## **STAFF REPORT ADDENDUM**

### **APPLICATION PRC C-377**

**APPLICANT:** Fairfax County Public Schools

**PROPOSAL:** To construct a 27,394 square foot building addition to the existing school, two new student pick-up and drop-off areas, and other site modifications

Figure 1: The proposed layout for PRC C-377 (Source – ADTEK Engineers, May 10, 2013)

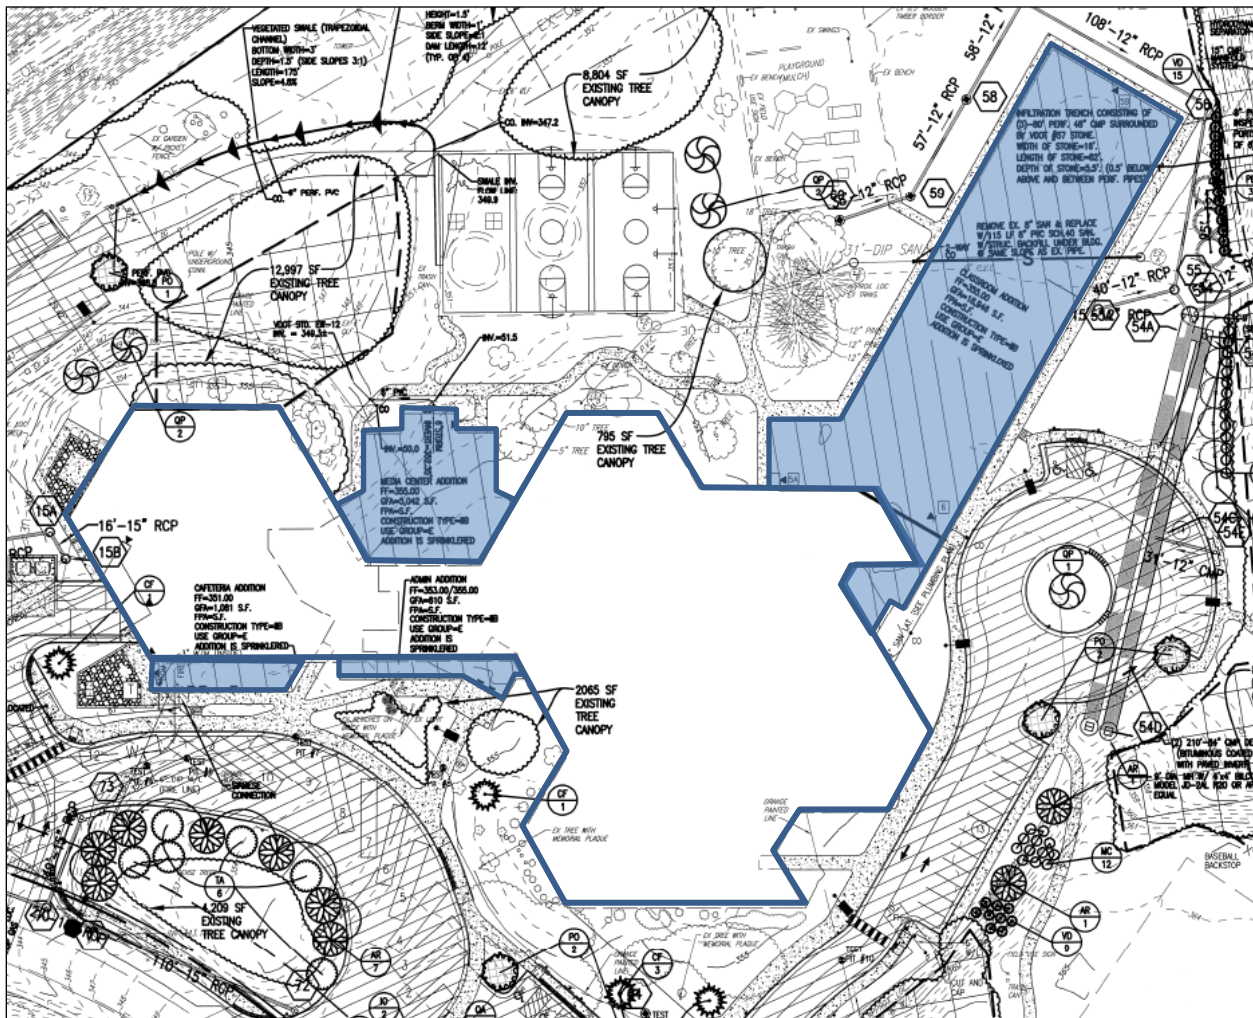
The applicant has modified the amount of square footage that would be added to the main school building (Figure 1):

- A 984 square foot administrative addition to the school's front entrance (previously 610 square feet);
- A 1,146 square foot expansion of the school's cafeteria (previously 1,081 square feet);
- A 5,042 square foot media center (no change); and,
- A 20,222 square feet addition for new classrooms (previously 18,946 square feet).

The applicant would still remove the temporary classroom annex and the temporary classroom trailers. In total, the applicant proposes 27,376 square feet of new construction, which is 1,303 more square feet than initially proposed. However, the building layout is substantially the same as previously proposed. The applicant has attributed this discrepancy to possibly listing the net floor area figures on the initial

submission as opposed to the gross floor area. Despite the new numbers, the applicant contends that no building design changes have been made since last year.

**Figure 2: The PRC Plan now shows an underground detention vault that would discharge into an infiltration trench. The arrow shows the direction of flow from the vault to the trench. (Source – ADTEK Engineers, May 10, 2013)**

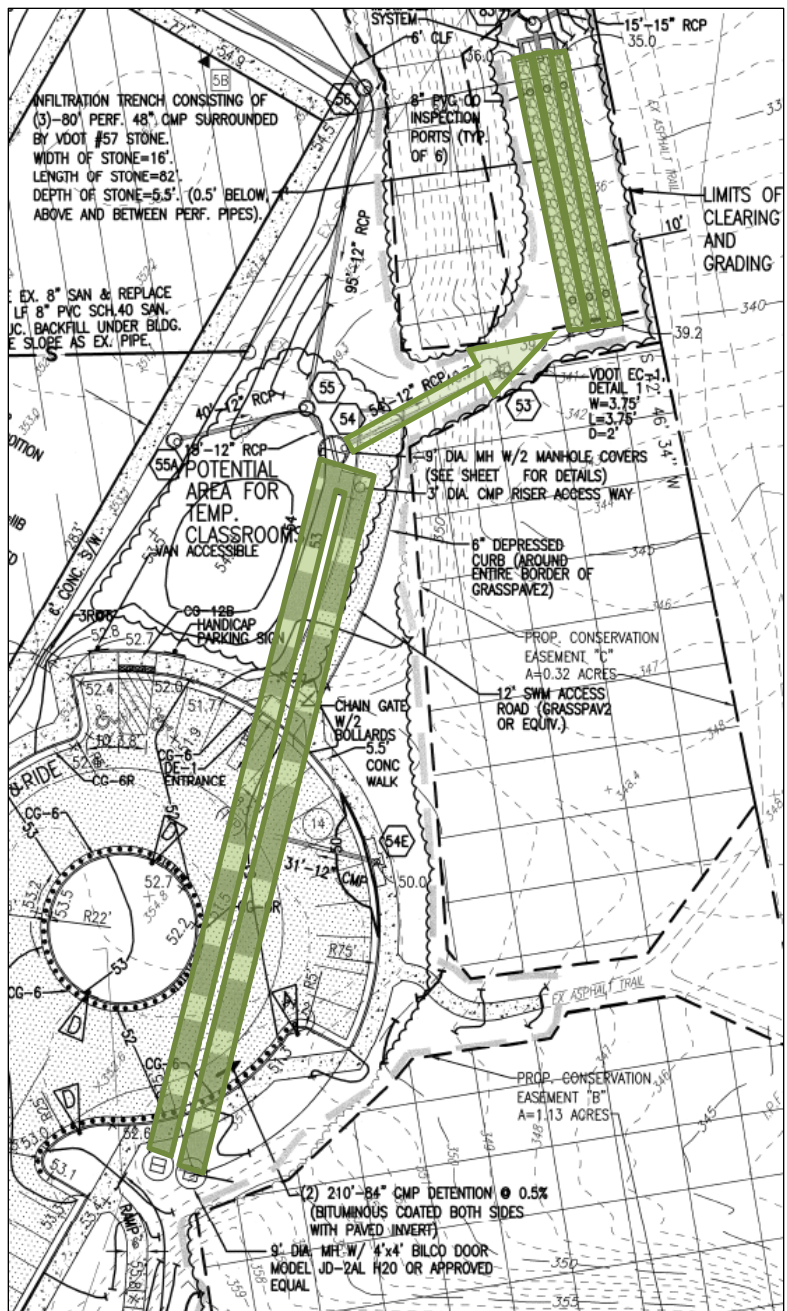
In response to the public feedback, the applicant has revised the stormwater management strategy for the proposed additions. The applicant's outfall narrative in the previous PRC Plan had indicated that Outfall #3 along the property's eastern boundary was likely inadequate due to the erosive volume of stormwater runoff leaving the site at that location. The Public Facilities Manual (PFM) requires off-site channel stabilization, such as a rip rap lined trench, to the nearest floodplain to slow the flow of water and create adequate outfall. However, adjacent property owners have indicated publicly that they would not agree to the applicant performing this work on their properties.

In lieu of the channel stabilization, the applicant has proposed an on-site underground detention vault (Figure 2) to slow the flow of water leaving Outfall #3. The applicant's revised outfall narrative on Sheet 6 of the PRC Plan states that this underground vault would utilize the PFM's detention method to reduce velocity of the runoff. This detention method reduces the water flow rate for 2- and 10-year storm events to a rate equivalent to that which would be seen if the property was in good forested condition.

The water leaving this detention vault would discharge into an approximately 80-foot long infiltration trench. This trench would be located along the southeastern property line. The applicant would need to clear existing vegetation and tree canopy to install
